Subdivision Ordinance Variance – 625 and 630 Franklin Street and 765 East Market Street (The Edge)

Subdivision Ordinance Variance Requests

DCSM Section 3.6.2.4

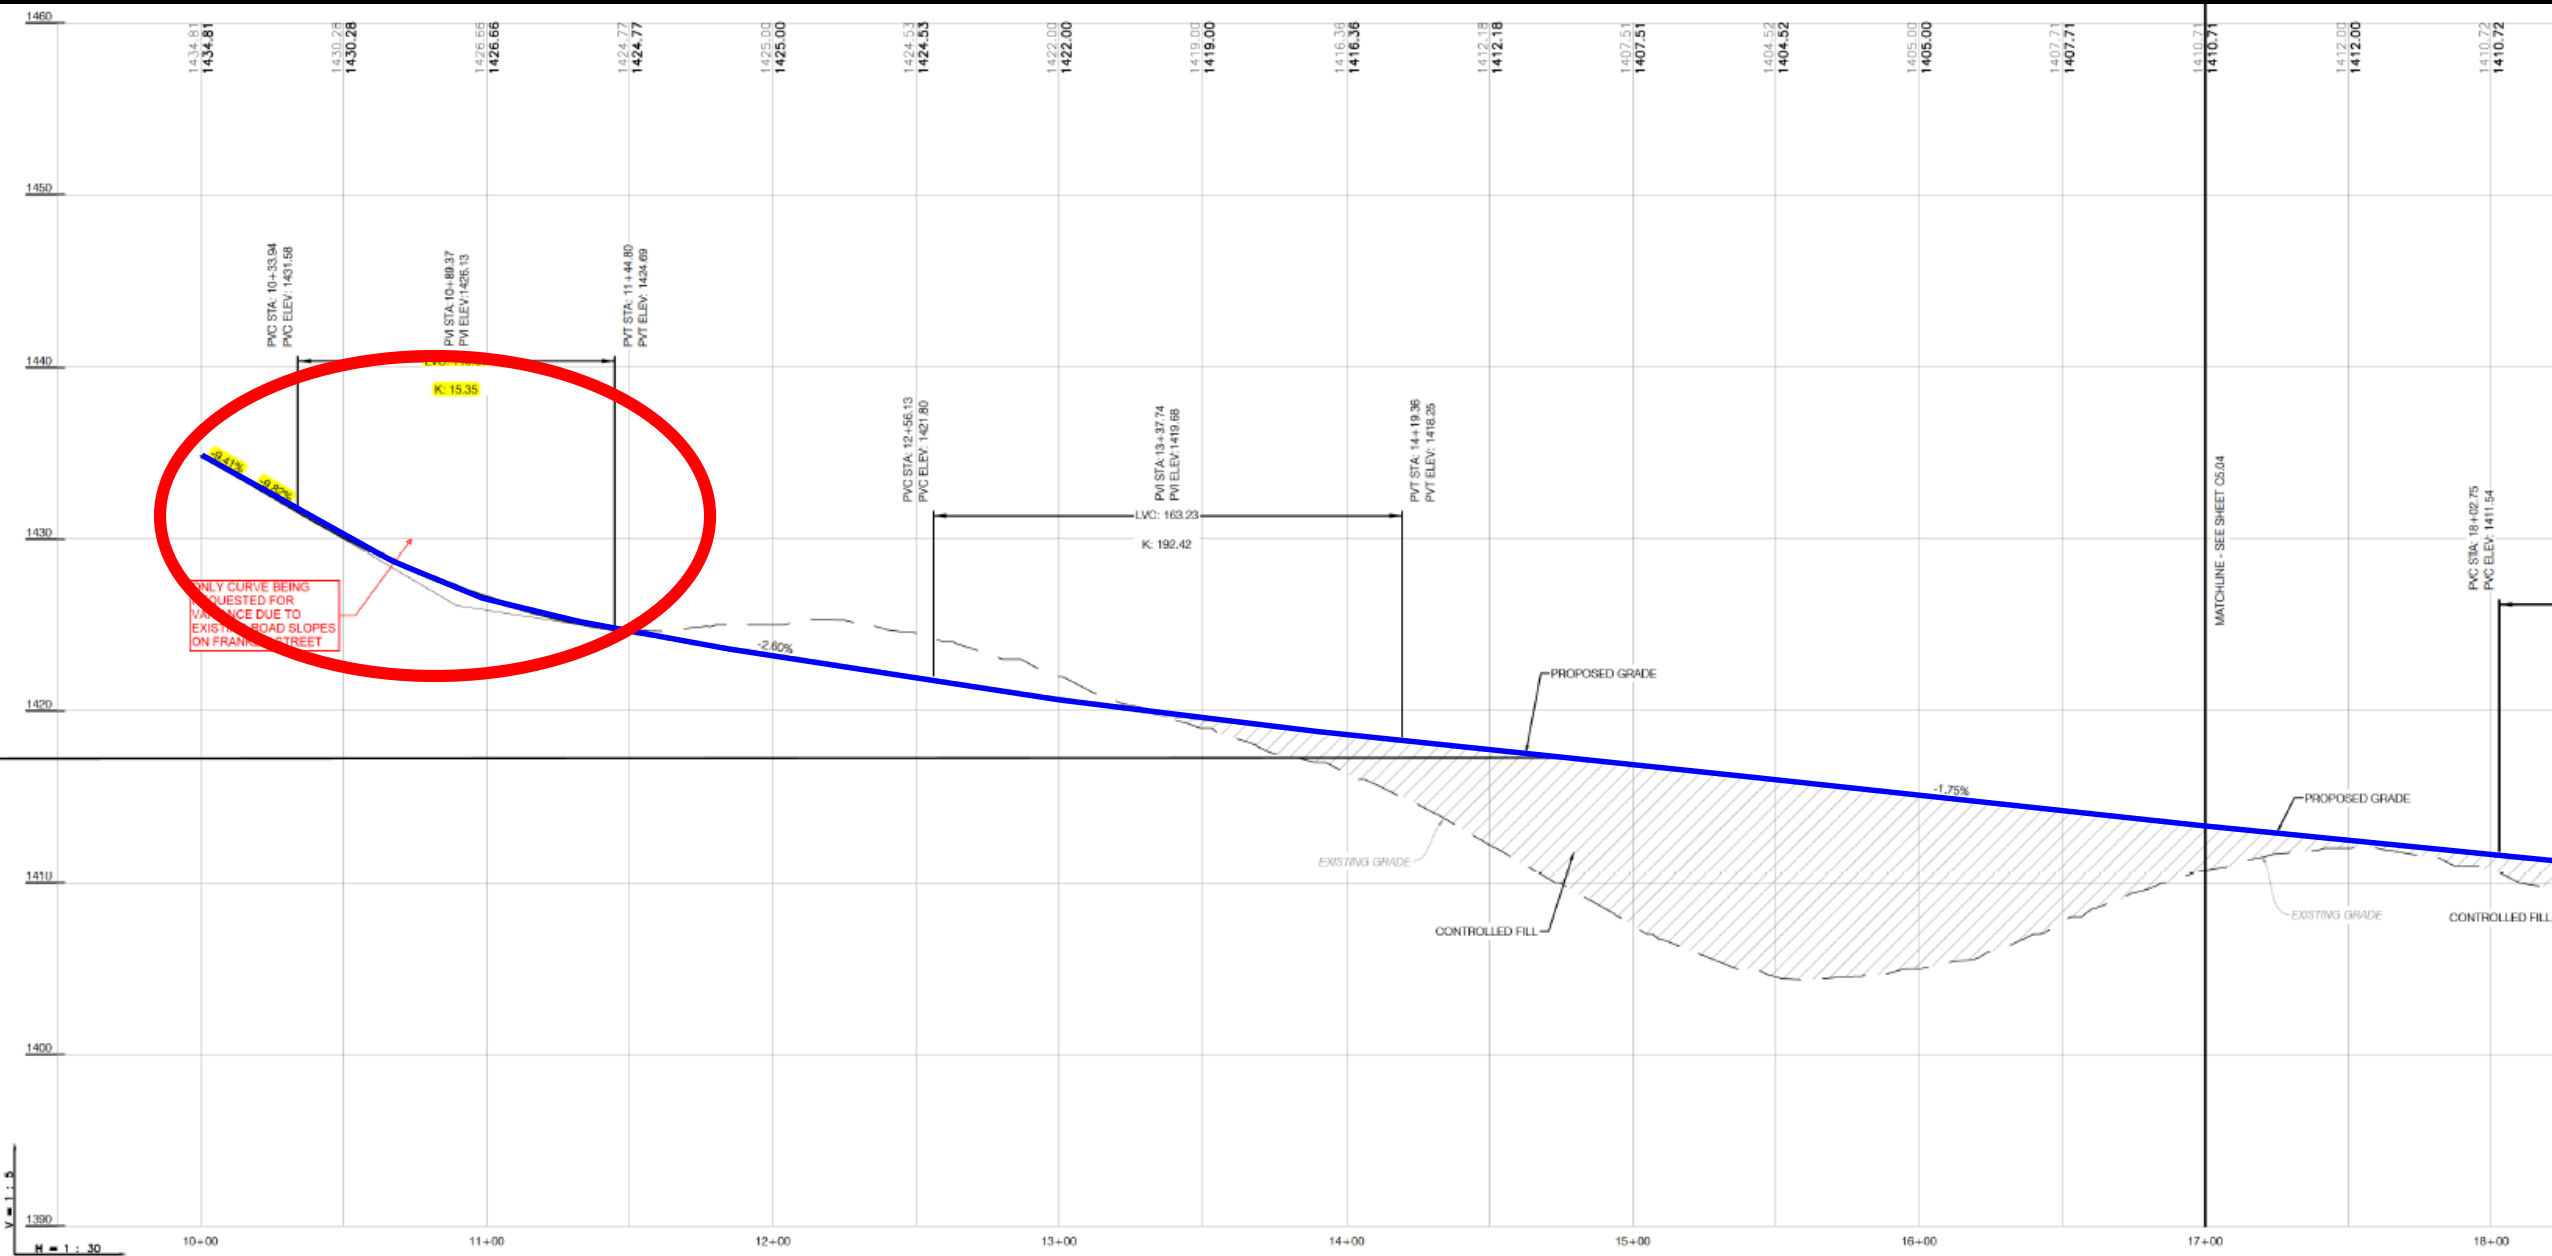
Section 3.6.2.4

The K value used to calculate the minimum length of the sag vertical curve in DCSM Section 3.6.2.4 shall not be less than 15.

DCSM Section 3.6.4.1

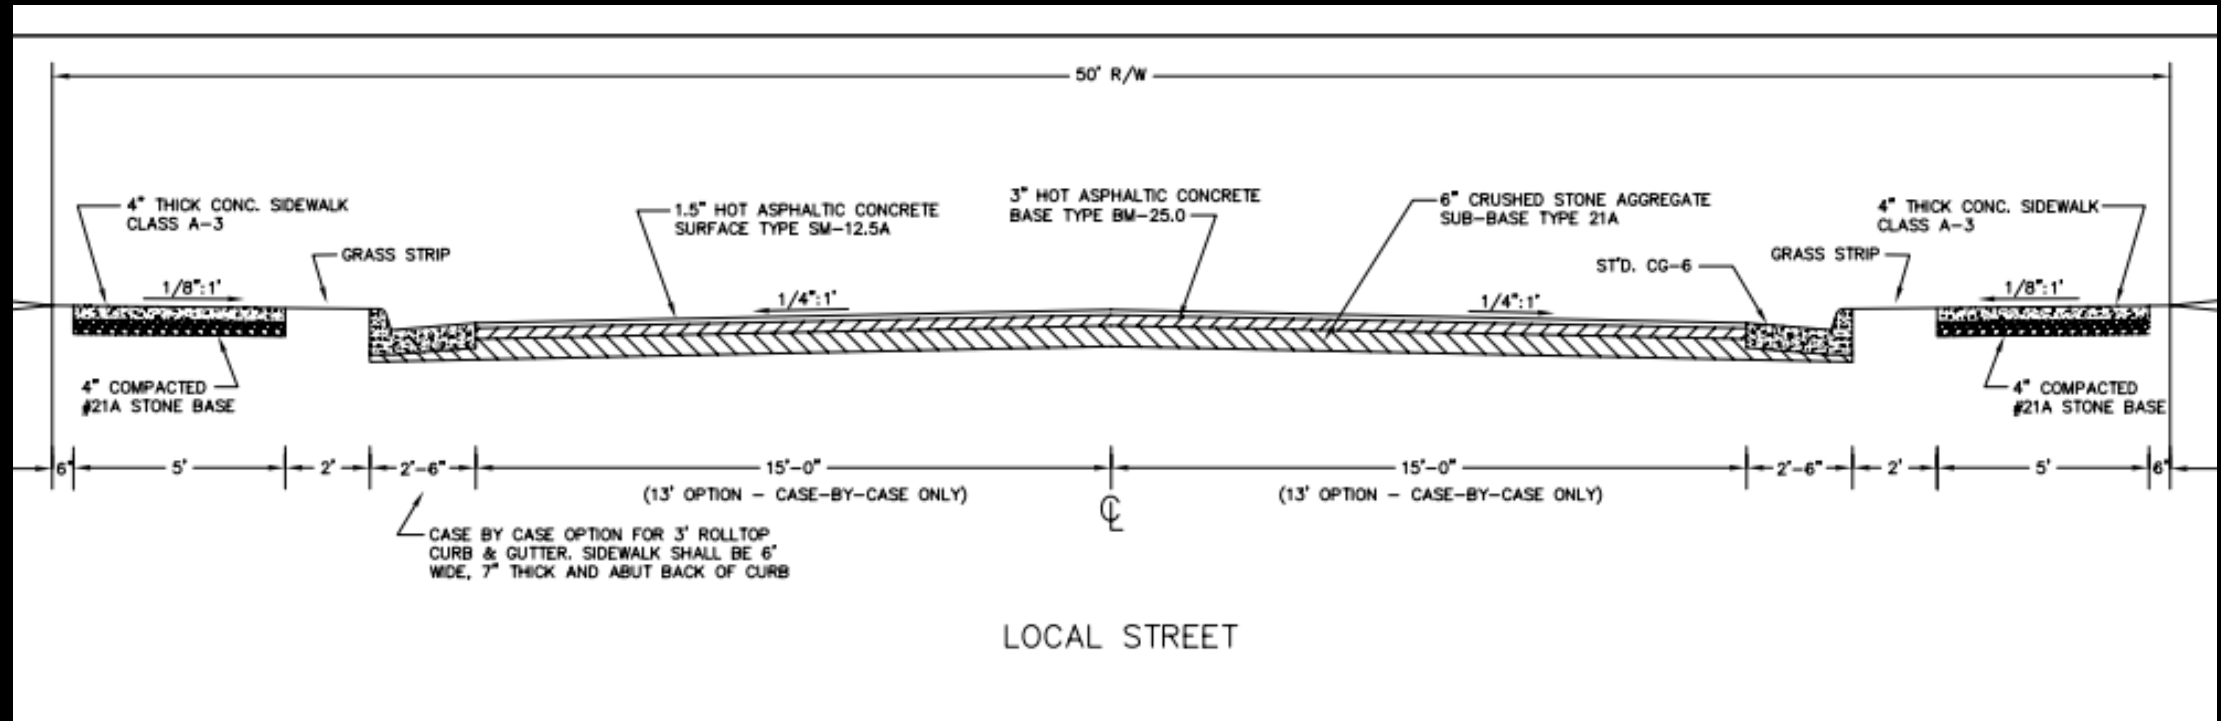
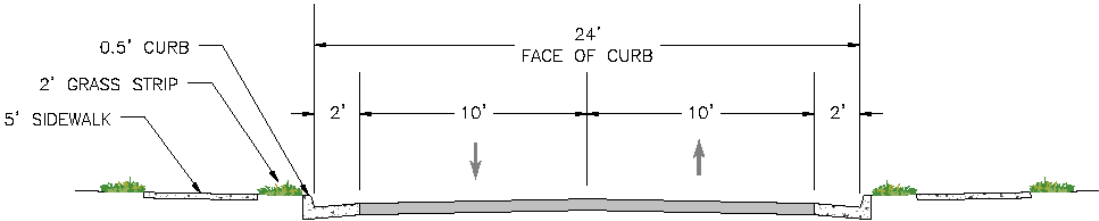
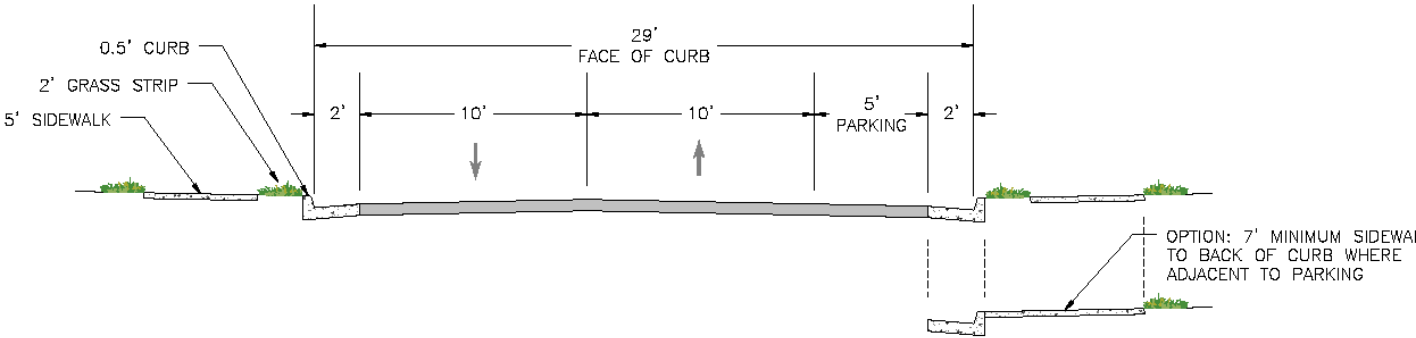
Appendix F Requirement for Local Street	Requested Variance (No On-Street Parking)	Requested Variance (On-Street Parking One Side)
Pavement Width	30 ft	20 ft	25 ft
Face-of-Curb to Face-of- Curb Width	34 ft	24 ft	29 ft

Appendix F Requirement for Local Street	Requested Variance (No On-Street Parking)	Requested Variance (On-Street Parking One Side)
Pavement Width	30 ft	20 ft	25 ft
Face-of-Curb to Face-of- Curb Width	34 ft	24 ft	29 ft

NO ON-STREET PARKING

PARKING ON ONE SIDE

Staff and Planning Commission (5-0) recommends approval of the requested variances with the following condition:
